Access Compliance Report

Public Rights-of-Way

(Pedestrian Signals)

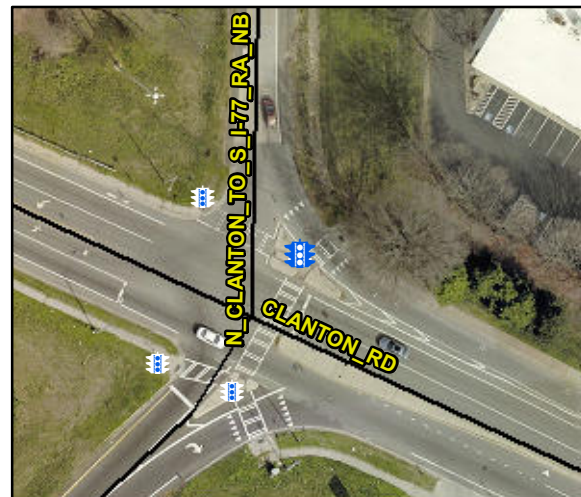
PROW/ADA: TMUTCD 4e.08, R404.3, R404.2, R404.7.3

Yes	B 1 Clear Xing Direction?	ClearlyMarked	N/A	B 2 Clear Xing Direction?	N/A
	B 1 Crossing Direction	To SW		B 2 Crossing Direction	N/A
Yes	B 1 DistanceTo XWalk (in)	0.0	N/A	B 2 DistanceTo XWalk (in)	N/A
No	B 1 DistanceTo Curb (in)	131.0	N/A	B 2 DistanceTo Curb (in)	N/A
Yes	B 1 Diameter (in)	2.0	N/A	B 2 Diameter (in)	N/A

Possible Solutions: Replace Signal Push Button With APS Button on New Post. Remove & Relocate Sign.
